Your Ref
AB/120/12/
Our Ref
PLAN-003608
Date
11/07/2013

Proposal: Erection of 1 No new dwelling (resubmission following AB/8/12/).
Site: Land adjacent to 84 Maltravers Street, Arundel, BN18 9DS.
AB/120/12/

Southern Water MapGuide Browser

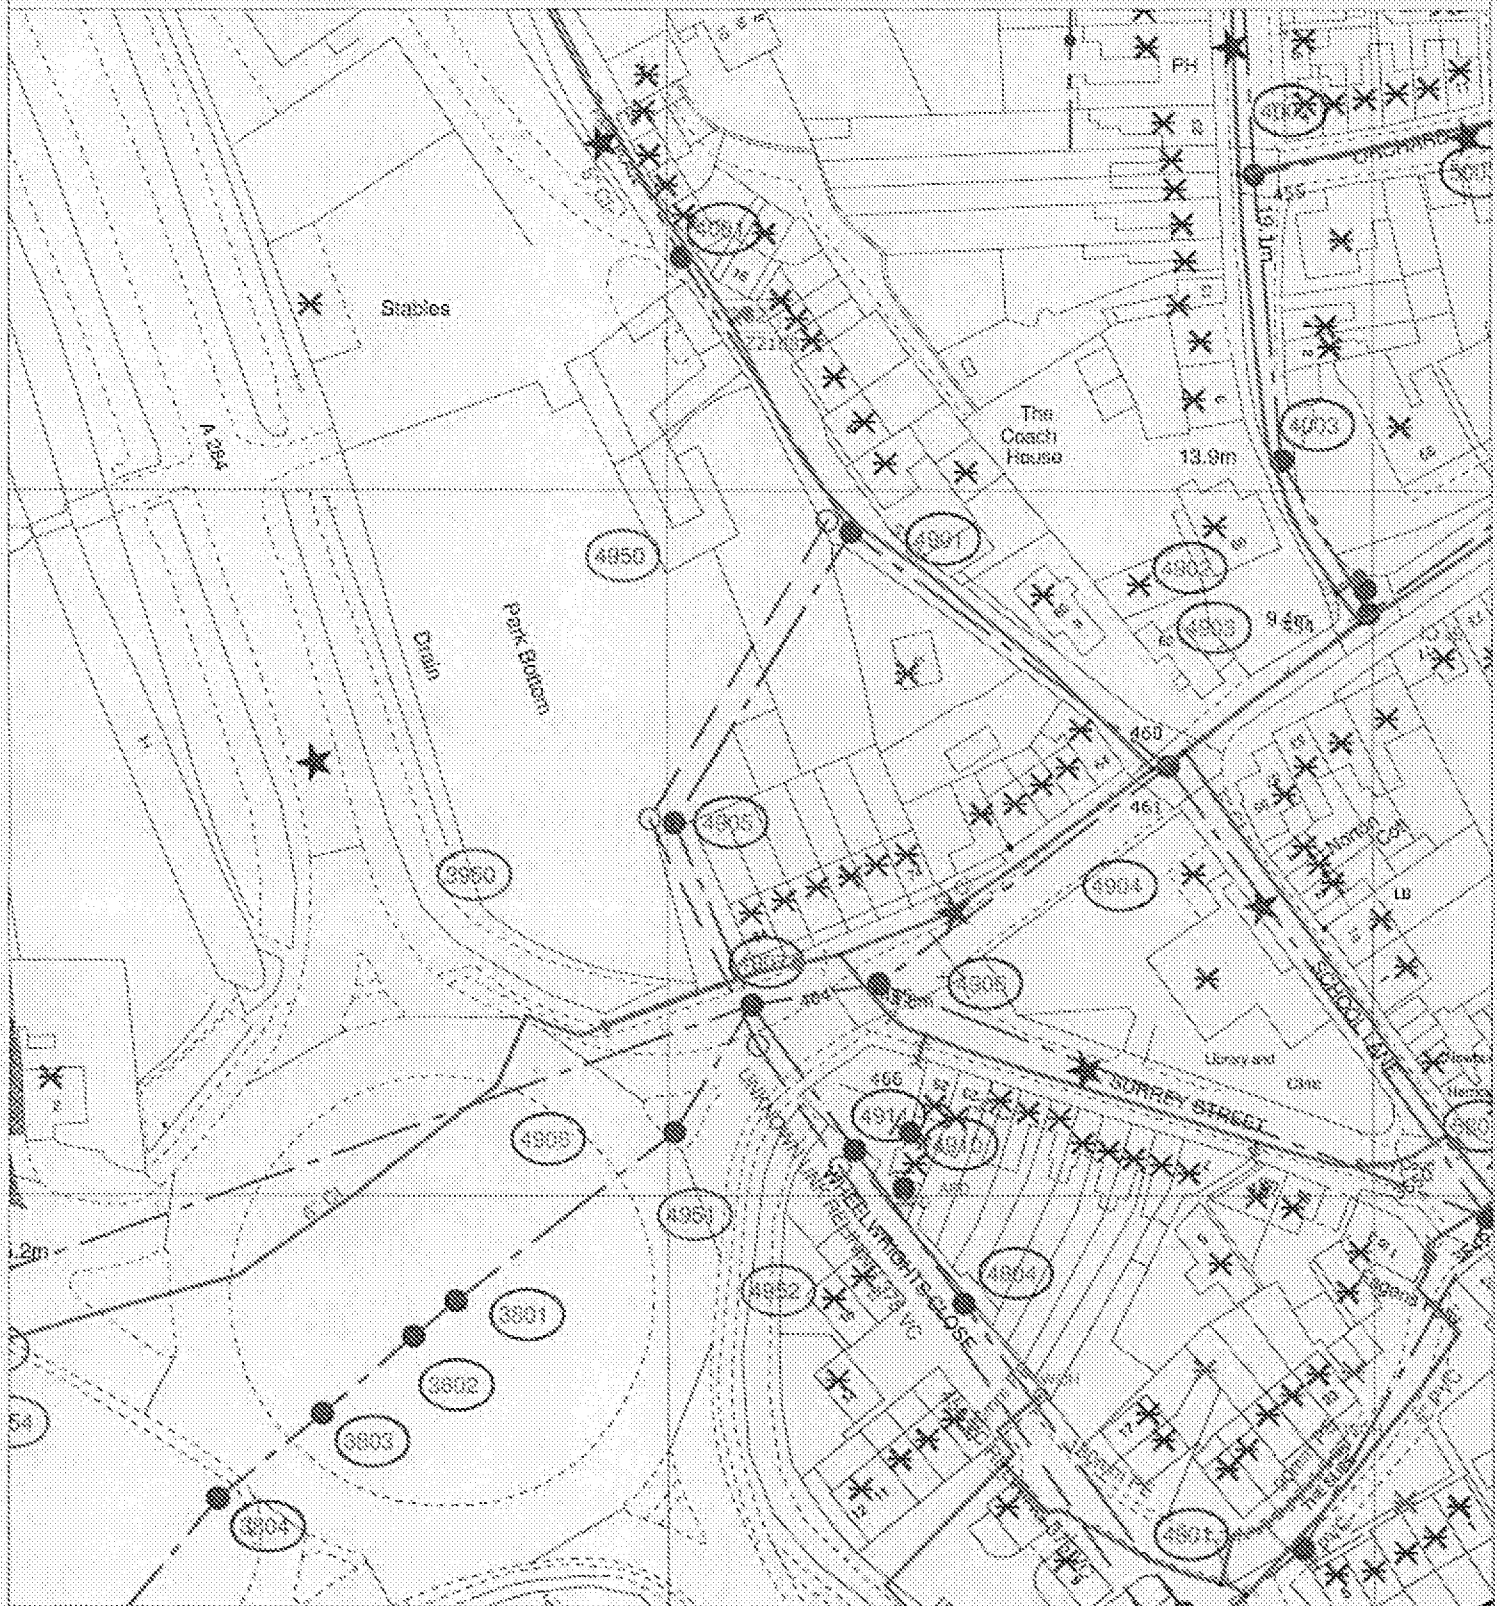
Please find attached a plan of the sewer records showing the approximate position of a foul and surface water sewer crossing the site. The exact position of the foul and surface water sewer must be determined on site by the applicant before the layout of the proposed development is finalised.

1. The 225 mm diameter foul sewer requires a clearance of 3 metres either side of the foul sewer and the surface water sewer requires a clearance of 3 metres either side of 375mm surface water sewer, to protect it from construction works and allow for future access for maintenance.
2. No development or new tree planting should be located within 3 metres either side of the centreline of the foul and surface water sewers.
3. No new soakaways should be located within 5 metres of a foul and surface water sewer.
4. All other existing infrastructure should be protected during the course of construction works.

It might be possible to divert the foul and surface water sewer, so long as this would result in no unacceptable loss of hydraulic capacity, and the work was carried out at the developer's expense to the satisfaction of Southern Water under the relevant statutory provisions. If the sewers cannot be diverted under a section 185 sewer diversion application, Southern Water issue an objection notice for the above proposal.

Alternatively, the applicant may wish to amend the site layout, or combine a diversion with amendment of the site layout. If the applicant would prefer to advance these options, items (1) – (4) above also apply.
